## T.E.D.S. Exception for the Site Plan of Van Gundy's Recycle Center/Salvage Yard

Re: Design Exception #DE6-13, 14, 15, 16 – Van Gundy's Proposed site on 4<sup>th</sup> Ave.

## DESIGN EXCEPTION #DE 6-13, 14,15 & 16

TITLE:	EXHIBIT "A"	SCALE:	N.T.S.	DATE:	04/04/06	DRAWN BY:	GAP	CAD I.D.#:	Gundy-Site.dwg
						CKD BY:	RWJII	PROJECT#:	F06-026

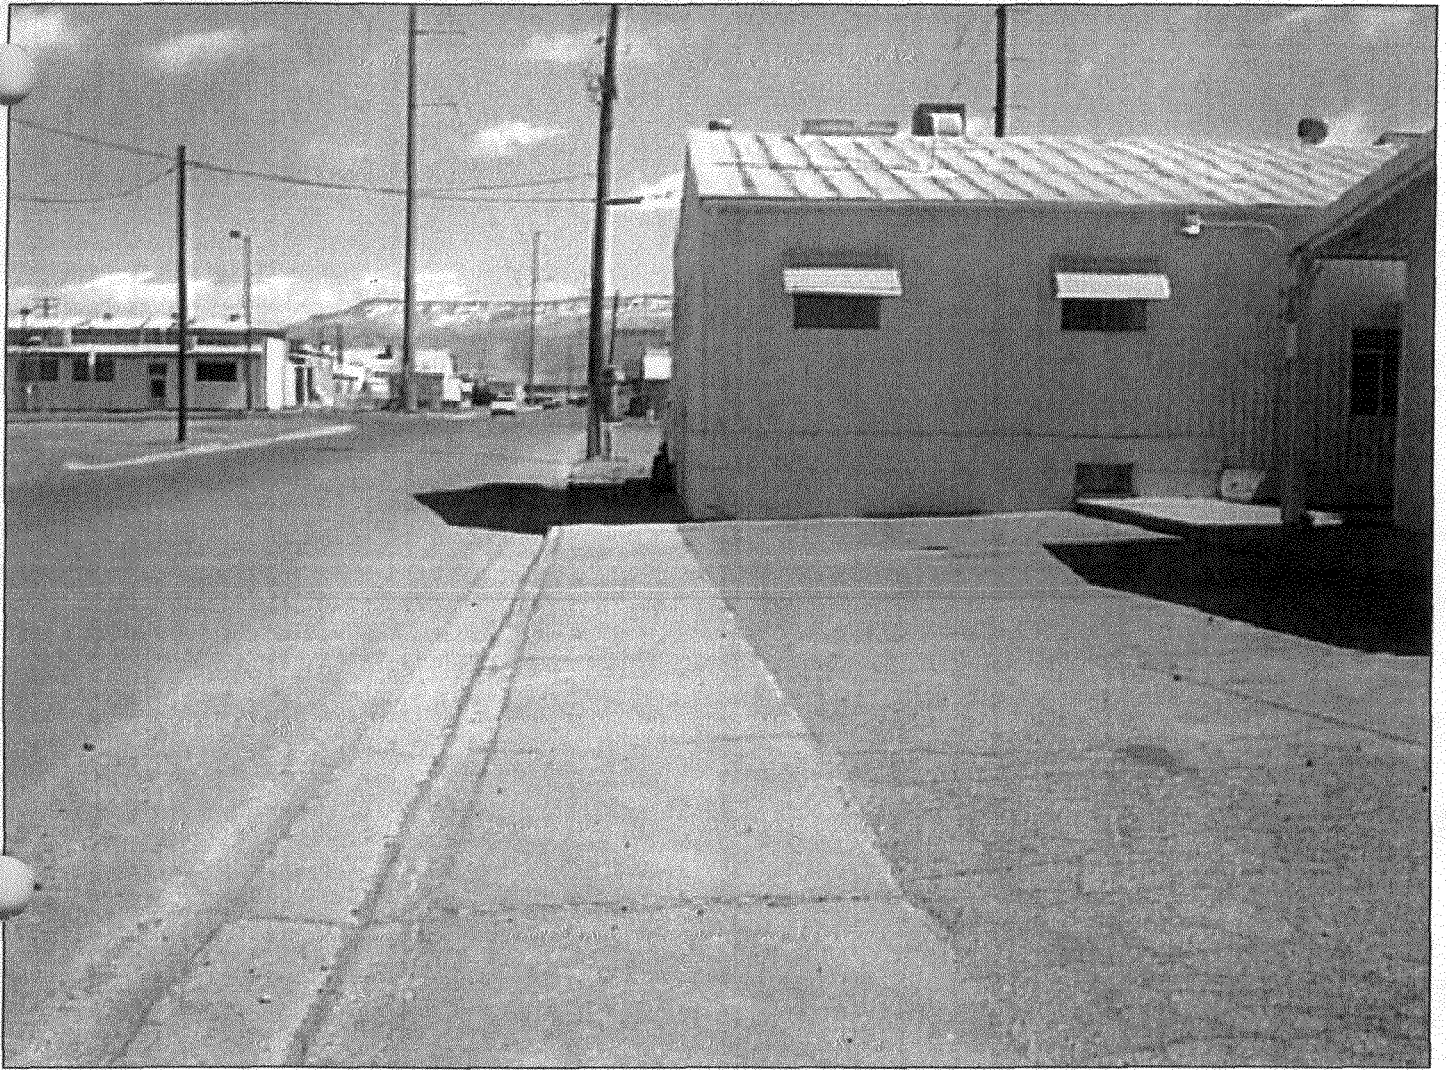
The Site Plan submitted to Community Development does not meet the TEDS standards in regards to providing a 14 Foot Multi Purpose Easement as shown on an Industrial Street Section (attached). As mentioned earlier, this site is approximately 20 percent smaller than the previous site and has more site constraints with the existing buildings and the triangular shape of the new lot. Quite simply, Van Gundy's needs as much room on the site for storage as possible. Additionally, the building in the northeast corner of the Sterling Site is approximately 6 foot from the existing street curb or 1 foot from the property line. A photo is attached as Exhibit A.

LOOKING EAST- EXISTING BUILDING  
APPROXIMATLY 6' FROM BACK OF CURB

- DE #13. Vortex Engineering requests the revision of Page ST-07, TEDS Chapter 5, to allow a five foot wide Multi-Purpose easement in lieu of the standard 14' easement. The Utility Coordinating Committee has reviewed this request and has provided a letter of support for this request.
- DE # 14. Vortex Engineering requests TEDS standard 4.2.5.1 be revised to allow 30' of storage between the new scale Van Gundy will install south of the main entrance off 4<sup>th</sup> Street and the flowline in the adjacent roadway.
- DE # 15. Vortex Engineering requests TEDS standard 4.1 be revised to allow driveways into the site to be offset less than the required 50' from driveways on the opposite side of the street.
- DE # 16. Vortex Engineering requests TEDS standard 4.3.1 be revised to allow 4<sup>th</sup> Ave. to function as a circulatory roadway between the scale and the storage yard.

- DE#13 – Approved  
DE#14 – Denied  
DE#15 – Approved

TITLE: EXHIBIT "B"

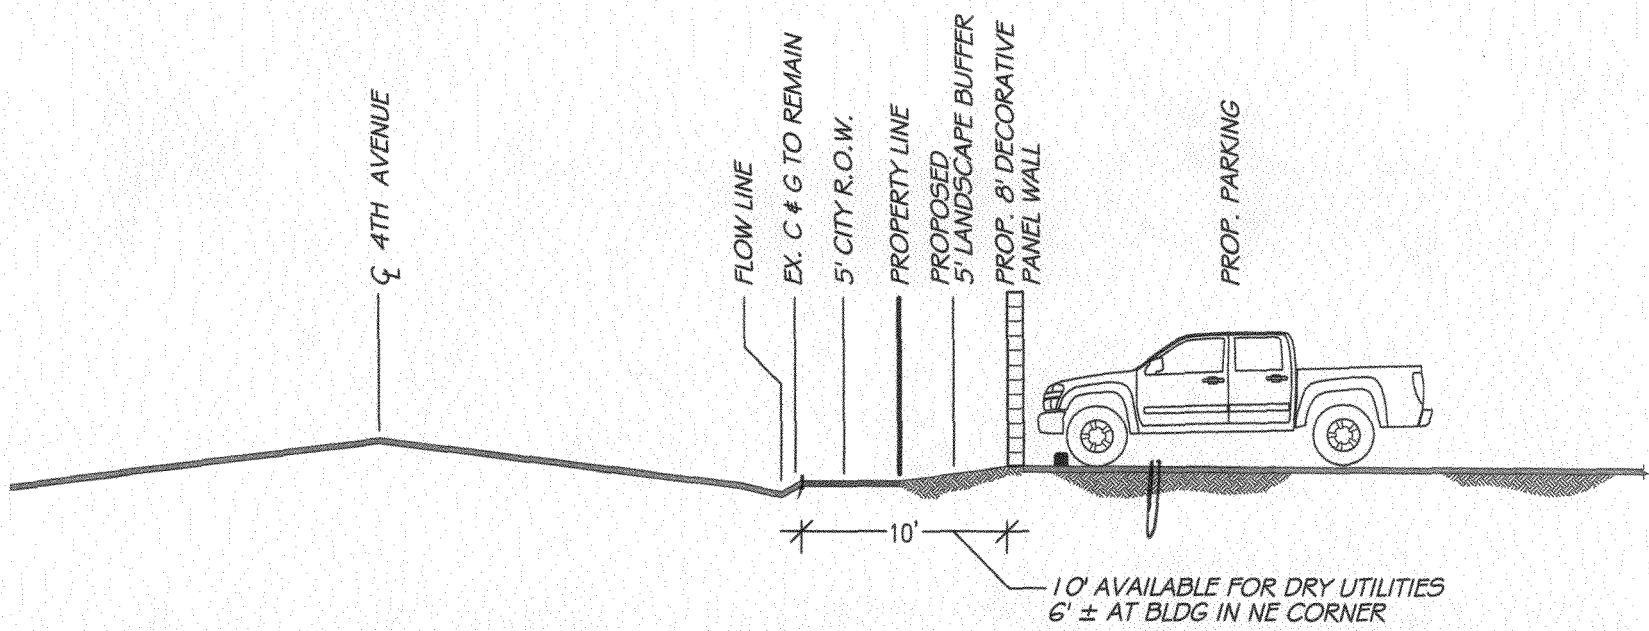
As part of the Conditional Use Permit (CUP), the City has required installation of an 8-foot high screening wall along 4<sup>th</sup> Avenue and 50 feet along each side from 4<sup>th</sup> avenue. Van Gundy's proposes to place the screening wall 5 feet from the property line to allow for additional storage and parking. Currently there is approximately 5 feet behind the existing curb to the property line. With the proposed wall placed 5 feet from the property line, this allows a total of 10 feet behind the curb for utilities. The exception to this is the location of the existing building in the northeast corner of the site. As discussed earlier, this building is approximately 6 feet from the street curb and the width is approximately 50 feet wide. Utilities would need to be placed in the 6-foot section between the building and the street curb. A sketch is attached as Exhibit B.

- Reduce to 14-foot multipurpose easement along 4<sup>th</sup> Avenue to 5 feet
- Eliminate the 14 foot multi purpose easement along 4<sup>th</sup> Avenue in front of the existing building (This would be for approximately 50 feet and utilities can be placed in the 6 foot section between the building and street curb)

**EXHIBIT C**  
**COMMUNICATION FROM BRESNAN**  
**SECTION FROM 29 ROAD RECONSTRUCTION**

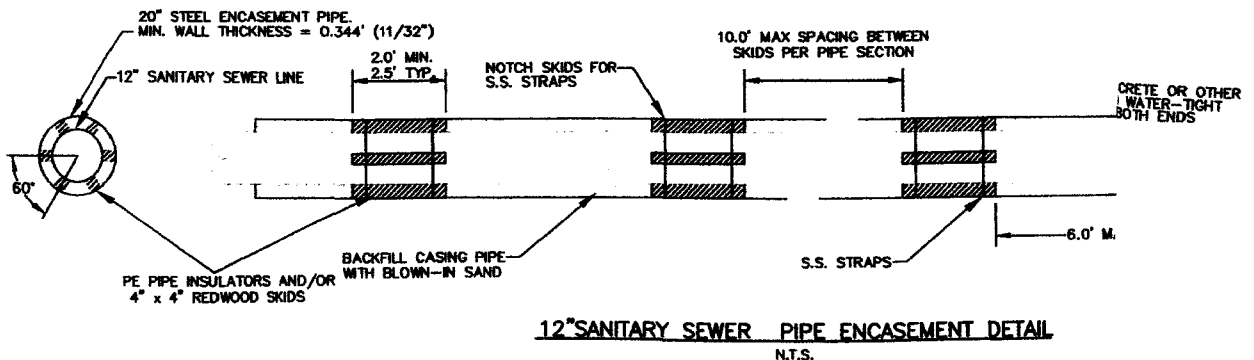
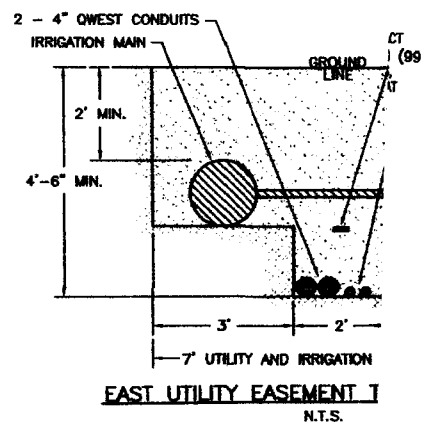
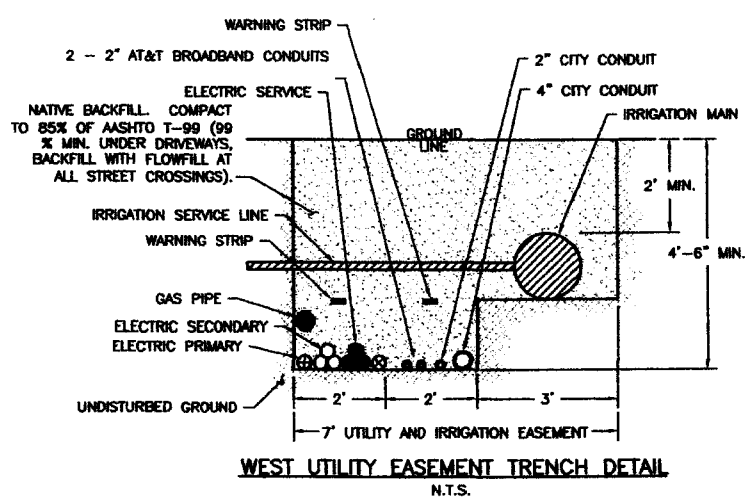
We understand that this easement is for “dry utilities”, Electrical, Cable, and Telephone. Including the area behind the curb, there will be approximately 10 feet for utilities. A sketch is included in Exhibit C. The 50-foot section in front of the building in the northeast corner of the site will have approximately 6 feet for “dry utilities”. We have checked with Xcel Energy, Bresnan Communications, and Qwest about this restriction. Bresnan has indicated approval (included in Exhibit C). We are awaiting comments from Xcel and Qwest.

I am writing in regards to the request to make an exception to the fourteen-foot multipurpose easement in the Van Gundy Simple Subdivision. The request asks for the multipurpose easement to be reduced from the normal fourteen feet to five feet. Bresnan Communications has no objections to this easement exception.
